LORSON RANCH

MINOR SKETCH PLAN AMENDMENT #2

DSD FILE NO.: SKP-19-1

Markup Summary

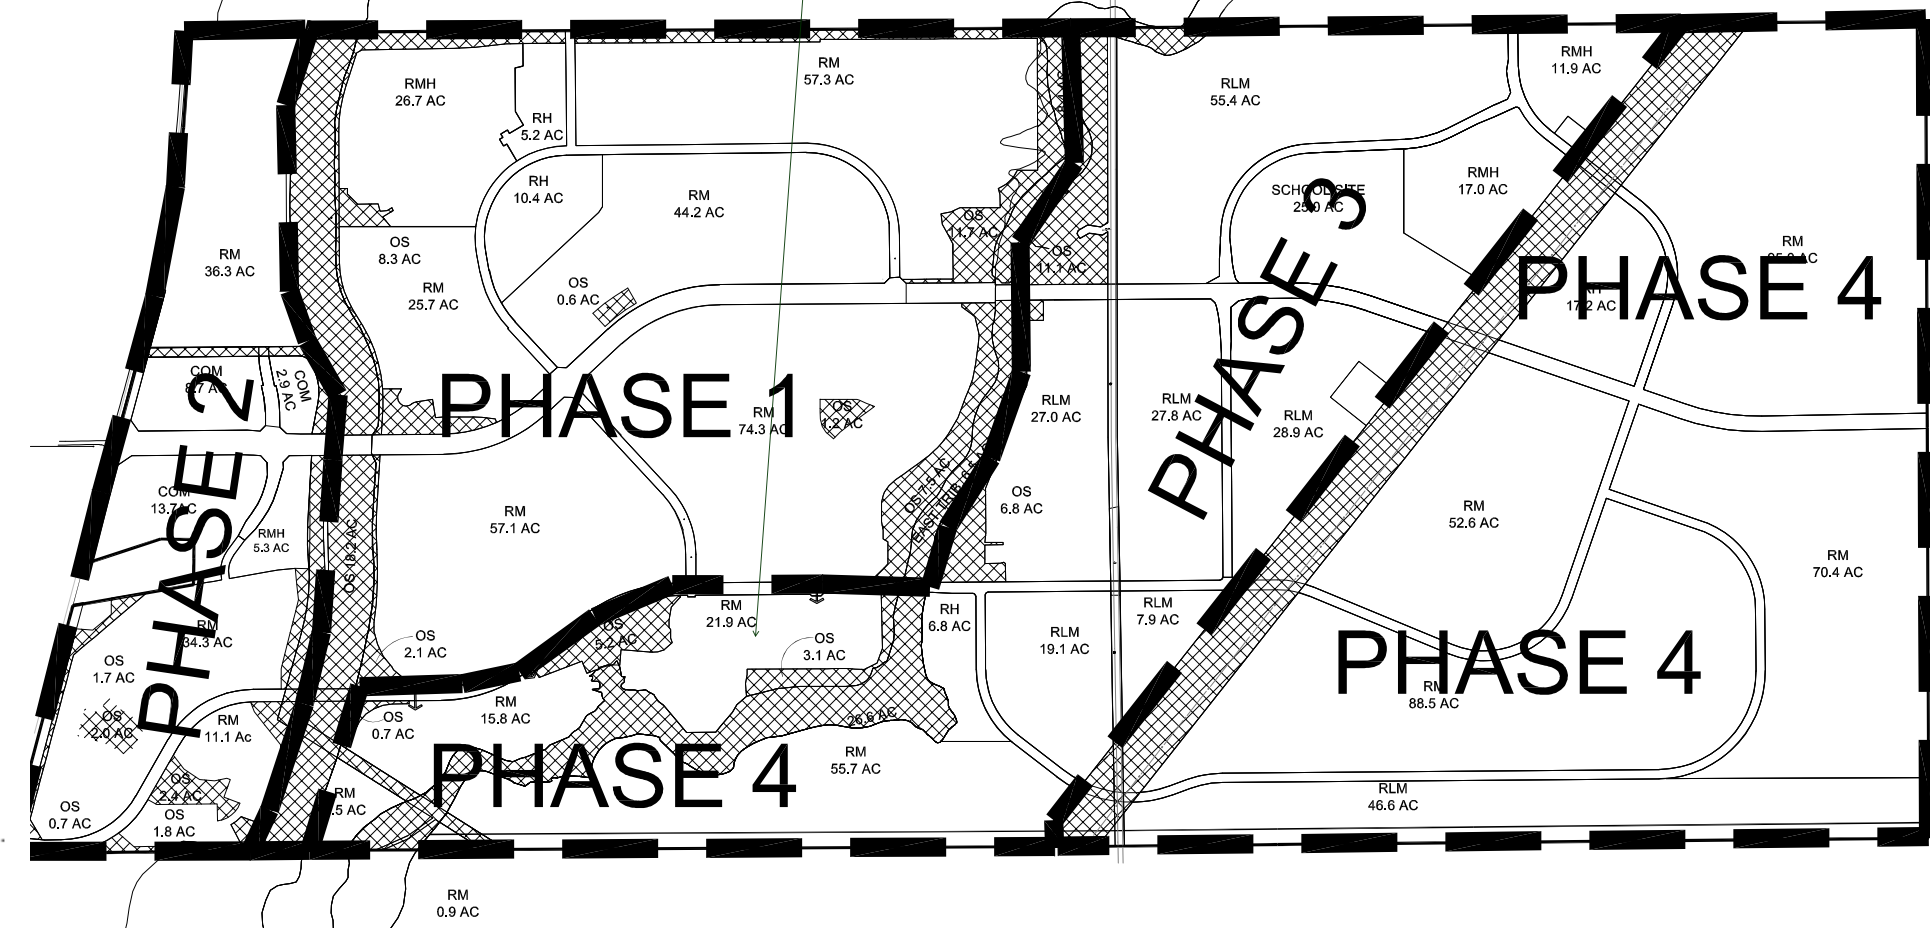
There is no calculation for 17-20 units in the actual acreage assignment so that density does not appear to have been approved?

Please do not change how the density range have been previously identified within the sketch plan 2015 SKP inserted above) to much confusion occurred. There should be one land use category with a specific range of density

existing platted units and planned units not recorded this should help to show the density transfer over an increase....

the densities for each LAND USE classification (RLM, RM, RMH, MF, RH) etc must be the same unit range as approved previously (remove proposed and existing) Please do not change the density range with that land use category- this has caused confusion and should not have been done that way in 2015 - I error ed not realizing the confusion it would cause; Please swap the use bubbles out with the appropriate RH or RM etc. If you have a new density that does not fit a current LAND USE category- add a new LAND USE Category for something. n the west developed residential lots may need to be RLM now id the density was not accomplished.

PHASING PLAN

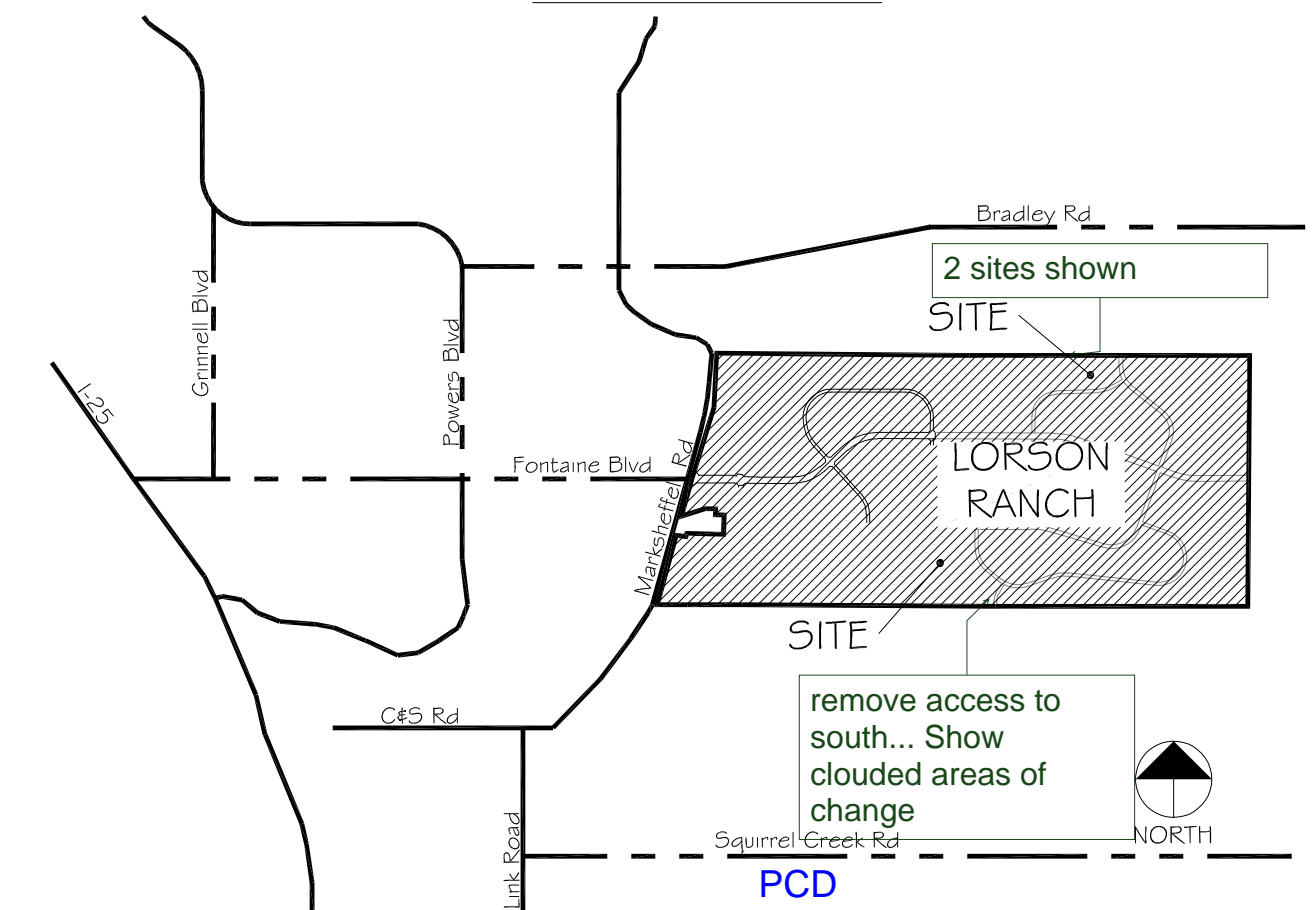
Creekside is in process so should be phase 3

SP2 OF 2

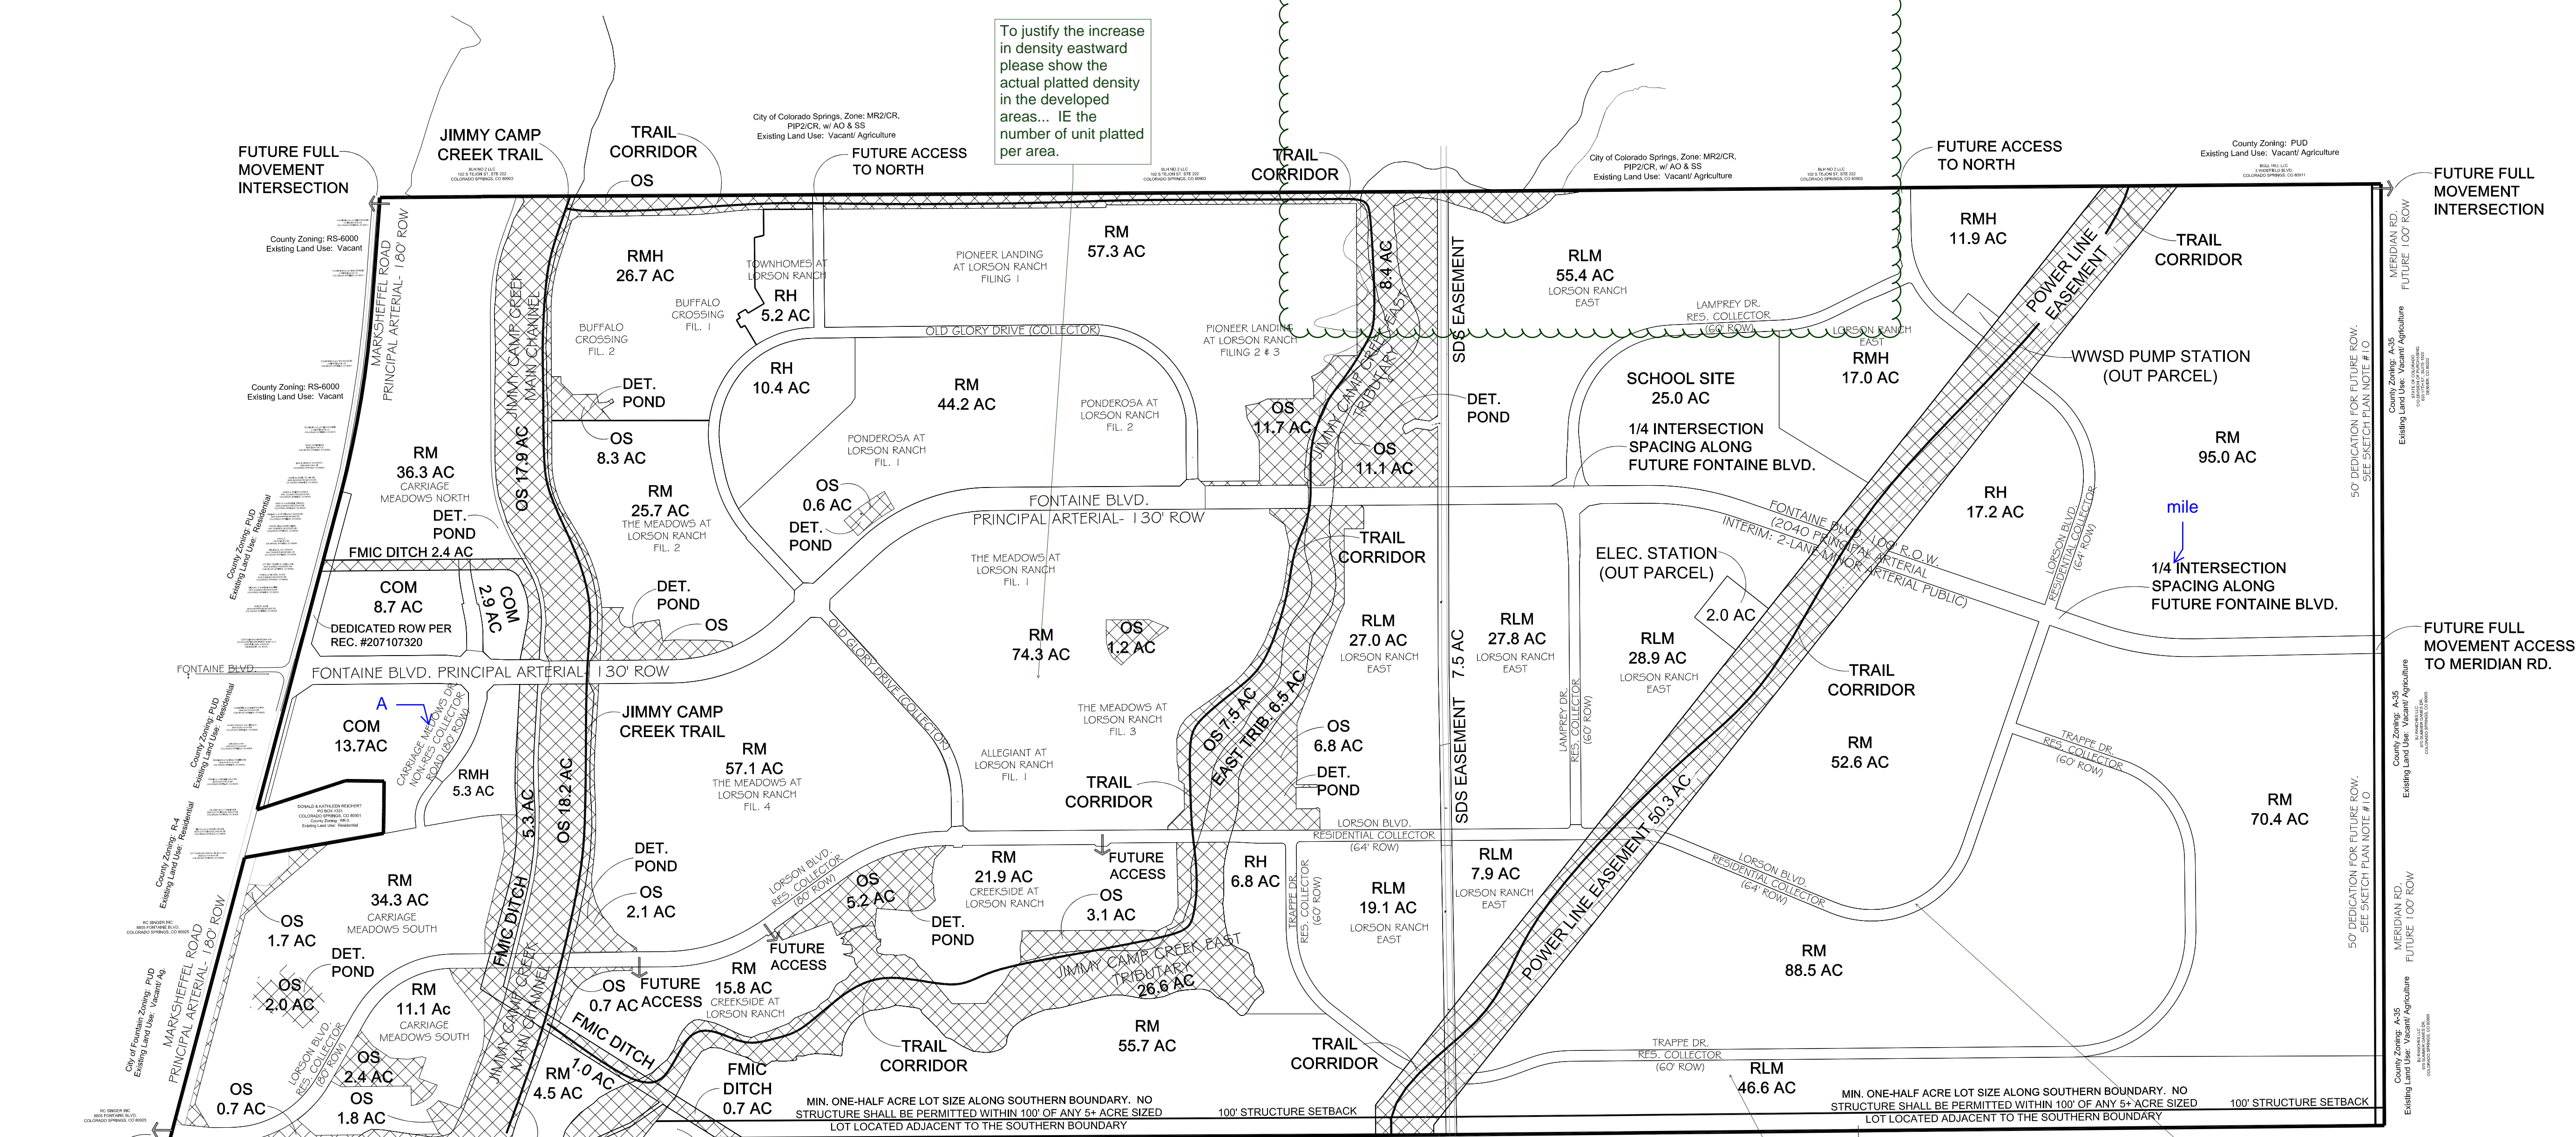
This application has received objections; this may require a hearing. The application needs to be detailed to avoid confusion

(this may be Major depending on the actual density numbers)?

To justify the increase in density eastward please show the actual platted density in the developed areas... IE the number of unit platted per area.

Cloud all areas that are changed

Staff does not support increasing the density adjacent to the rural properties. There has been years of understandings that the density will not be increased south of TRAPPE DR.

CLOUD All areas proposed to be revised from the 2015 amendment SKP 15 1
